# Roadway Pavement Reclamation, Leveling and Resurfacing Improvements on Town-wide Roadways

## Addendum #1

DATED August 13, 2020

TOWN OF SPENCER  
 EROSION CONTROL LOCATIONS  
 PROPOSED ROADWAY IMPROVEMENTS

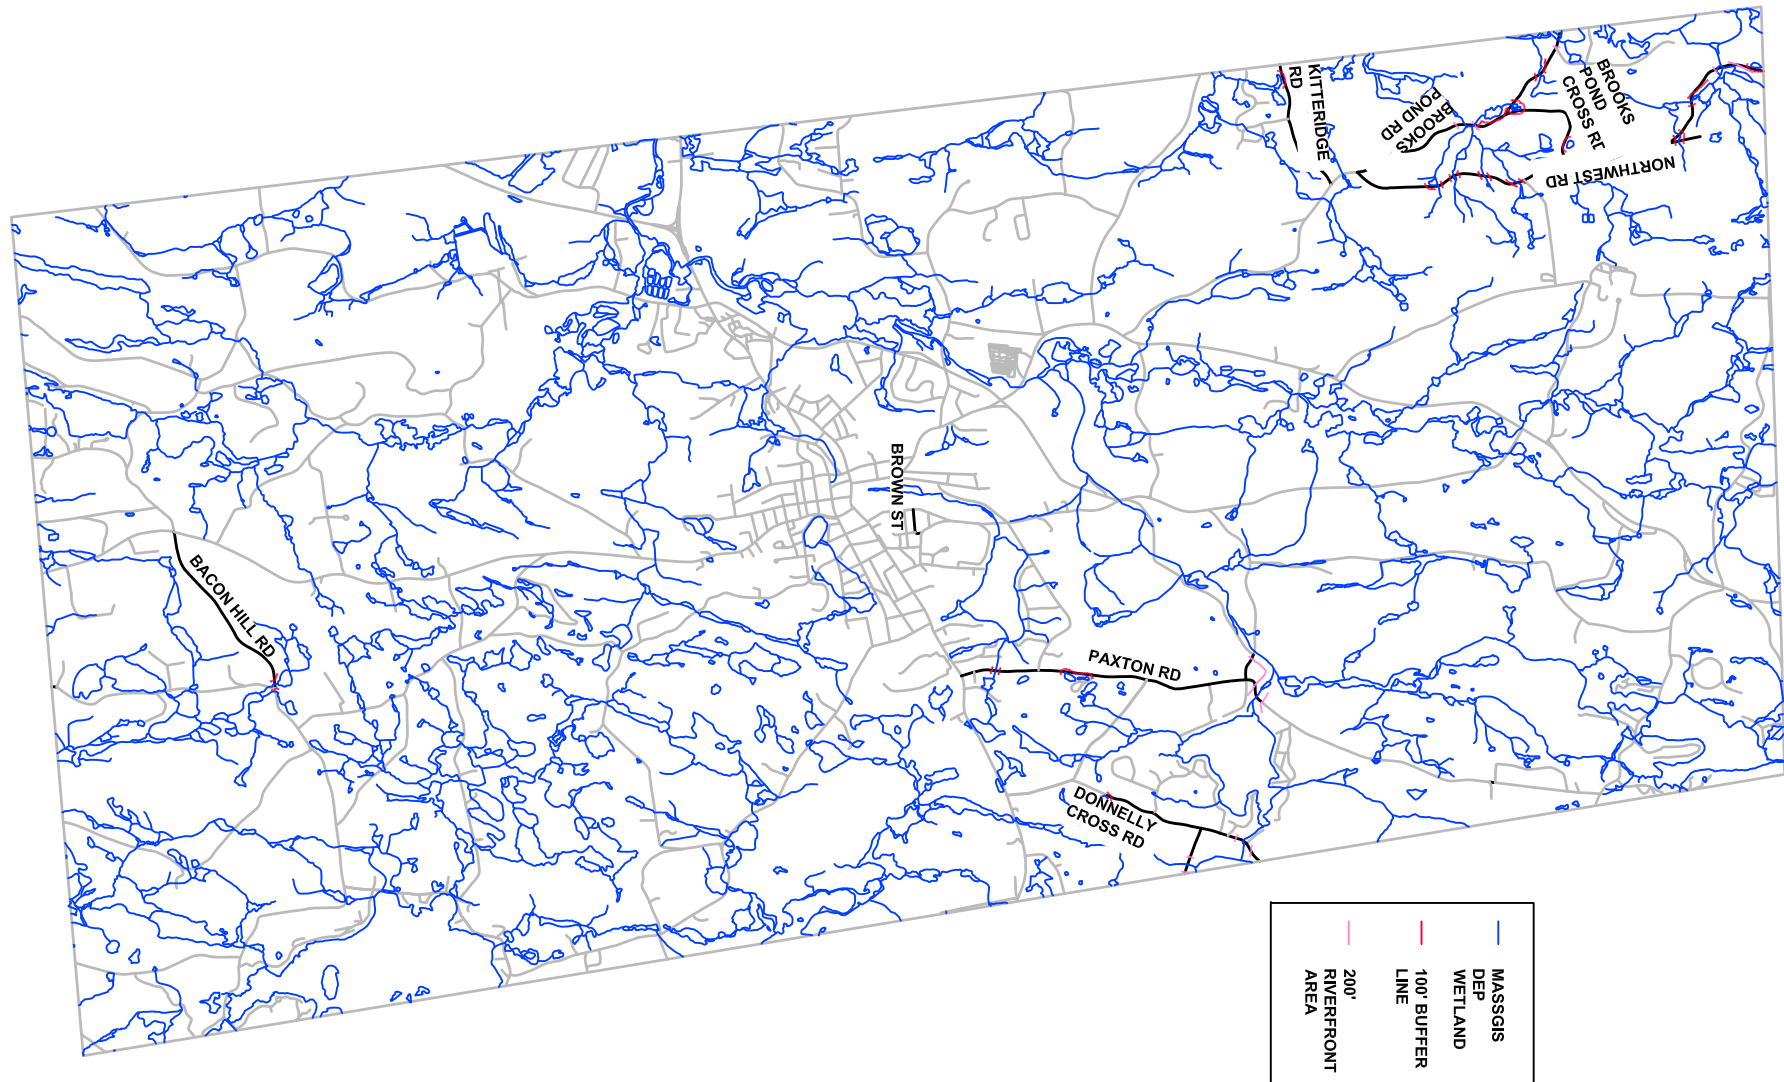
2. Please provide locations of erosion controls to be installed on the project? **See attached reference plan.**
3. The specs for Item 156.4 – Shoulder Crushed Ballast call out for 4” minus crushed stone to be placed on the shoulder in one or two more layers. Is also states the finished surface of the millings shall be compacted with a plate compactor. Is it the intent to place millings on top of the shoulder crushed ballast? **No.** If so, will the contractor be paid for both items (156.3 – shoulder millings & 156.4 – shoulder crushed ballast)? **Intended shoulder treatments are will consist of one or the other - Never on top of each other. Item 156.3 is intended to support the shoulder edges on generally flat roadways. This material is expected to be compacted after shouldering material placement. Item 156.4 is intended for shoulder support along hill roadways where gutter erosion may occur. This material is not expected to be compacted but rather placed. See attached revised spec for Item 156.4.**

- Bidders are directed to remove the existing Specification Page 60, “Shoulder Crushed Ballast” and replace with the attached page titled, “Shoulder Crushed Ballast”
- Bidders are instructed to insert the attached page titled, “Town of Spencer Erosion Control Locations Proposed Roadway Improvements”. This page shows the locations of erosion controls and supplements the response to question #2 above
- Bidders are instructed to remove and replace the bid form with the attached bid form.

ALL EROSION CONTROLS LOCATIONS ARE TO BE CONFIRMED WITH THE TOWN PRIOR TO INSTALLATION BY THE CONTRACTOR.
